The Woods at Copper Creek PUD - Vicinity of 4600 NE 23rd Avenue ZON2011-00095

**APPROVAL** of a request from HDR Land Development, LLC (owner) represented by Larry Handley (officer) and Richard N. Downs Trust (owner) with regard to property in the vicinity of 4600 block of Easton Boulevard:

ZON2011-00095 & 13-2011-1.30

1. **Purpose of Request:** The applicant is proposing to amend the Woods at Copper Creek PUD Conceptual Plan to revise five acres at the southeast corner of the PUD from multiple-family residential to single-family residential. The approved "Woods of Copper Creek" PUD Conceptual Plan provides for approximately 71 acres for 60-foot wide lot single-family residential development, approximately 22 acres of 70-foot wide lot single-family development, and approximately 18 acres for multiple-family residential development to be defined with a future PUD Conceptual Plan amendment.

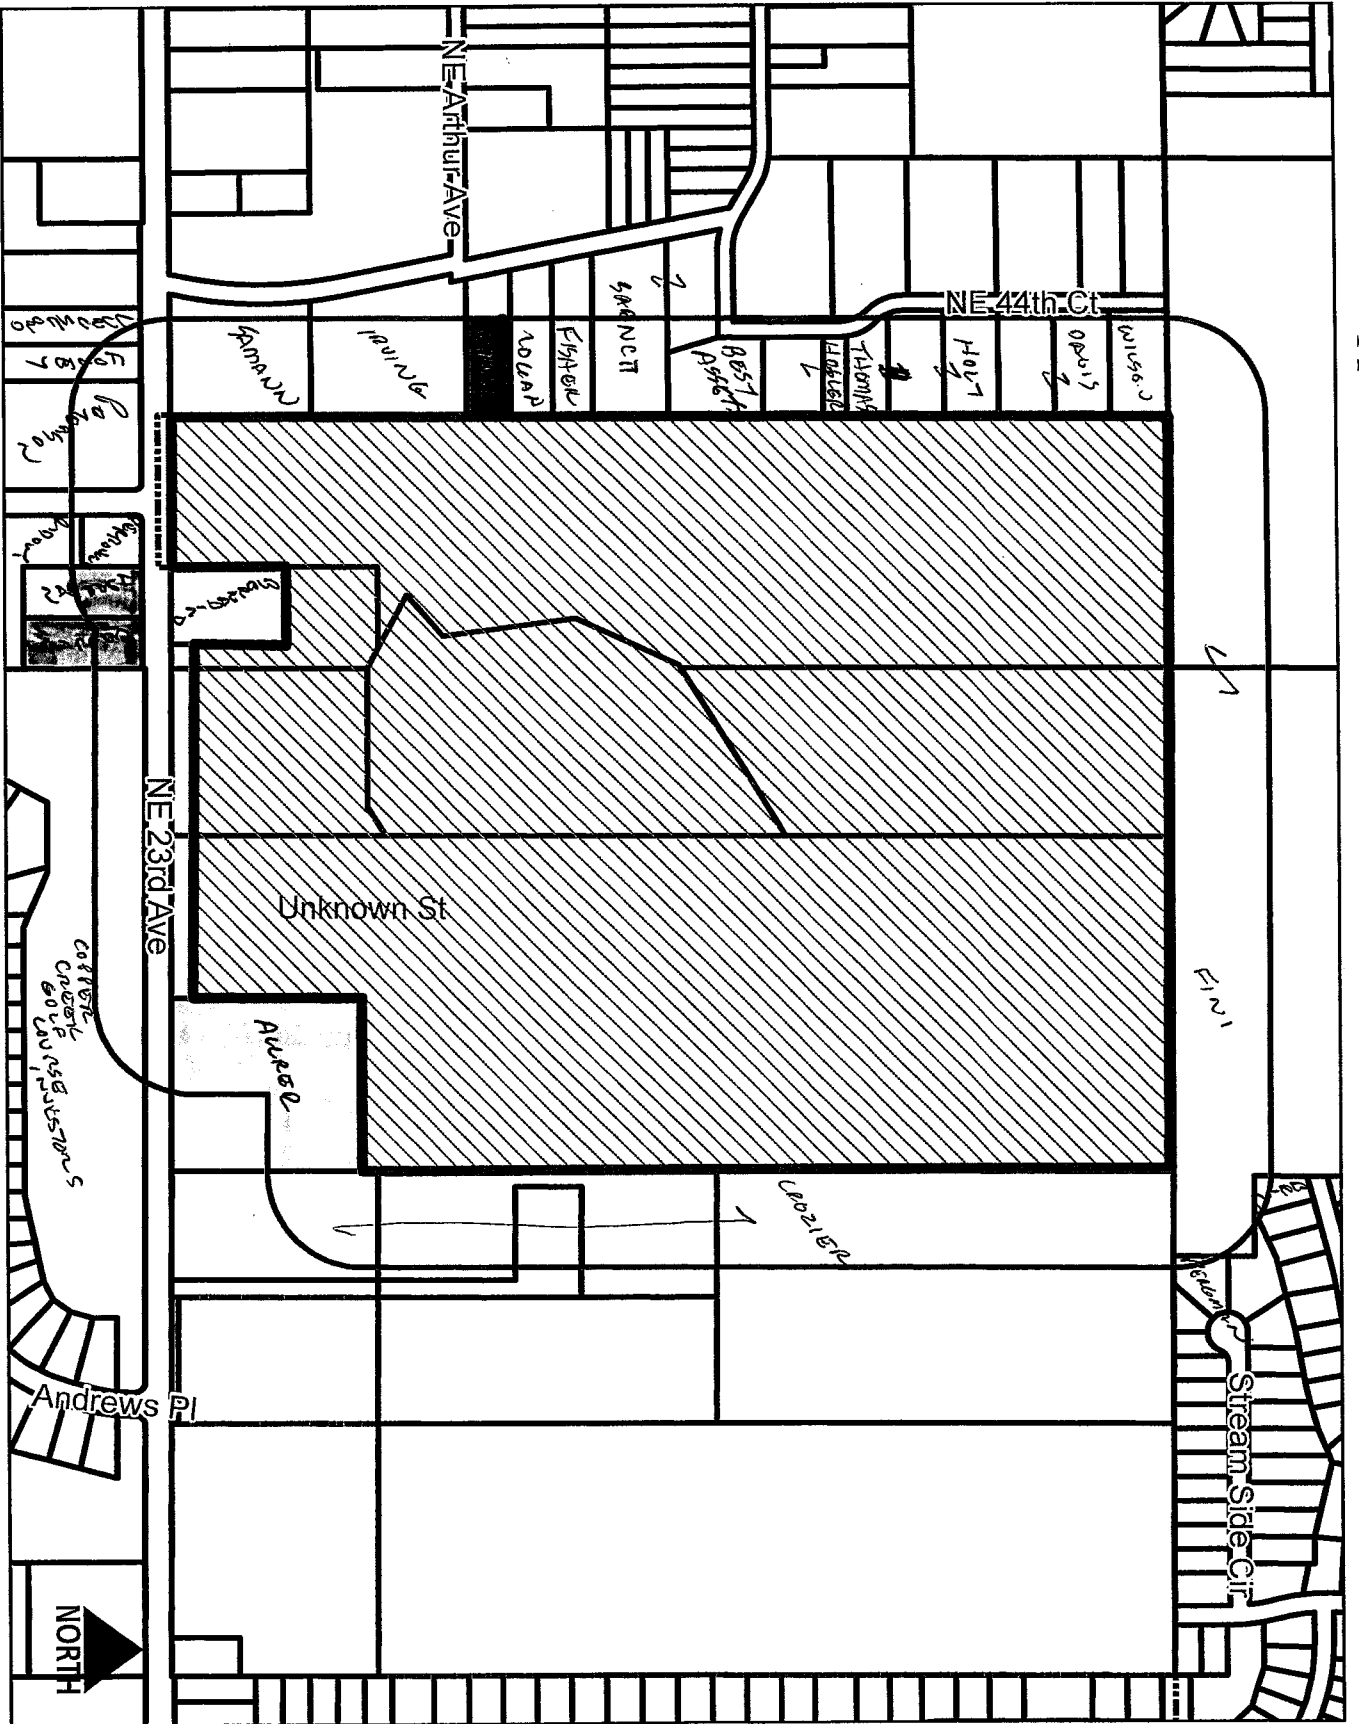
Part A) Staff recommends approval of the amendment to "The Woods of Copper Creek" PUD Conceptual Plan subject to the following revisions:

1. Each single-family residential lot shall provide one 1.5-inch caliper street tree, one ornamental or overstory tree in each front yard, and one 1.5-inch caliper overstory tree in the rear yard.
2. Demonstration of the sanitary sewer that would serve the additional single-family lots as provided on the preliminary plat.
3. Provision of a note to state the development will comply with the International Fire Code Section D107.1, which requires a secondary separate and approved fire apparatus access road where the number of single-family dwelling units exceeds 30.

Part B) Staff recommends approval of the amendment to "The Woods of Copper Creek" Preliminary Plat subject to the following revisions:

1. Compliance with all administrative review comments by the Permit and Development Center.
2. Each single-family residential lot shall provide one 1.5-inch caliper street tree, one ornamental or overstory tree in each front yard, and one 1.5-inch caliper overstory tree in the rear yard
3. Provision of low-level shrubs within all landscape islands within cul-de-sacs and traffic circles planted by the developer and owned and maintained by a homeowners association.
4. Any cul-de-sac over 150 feet in length must have a minimum diameter of 96 feet.
5. Provision of a note to state the development will comply with the International Fire Code Section D107.1, which requires a secondary separate and approved fire apparatus access road where the number of single-family dwelling units exceeds 30.

6. Demonstration of how Outlots Y & Z will be owned and maintained to the satisfaction of both Polk County and the City of Des Moines.
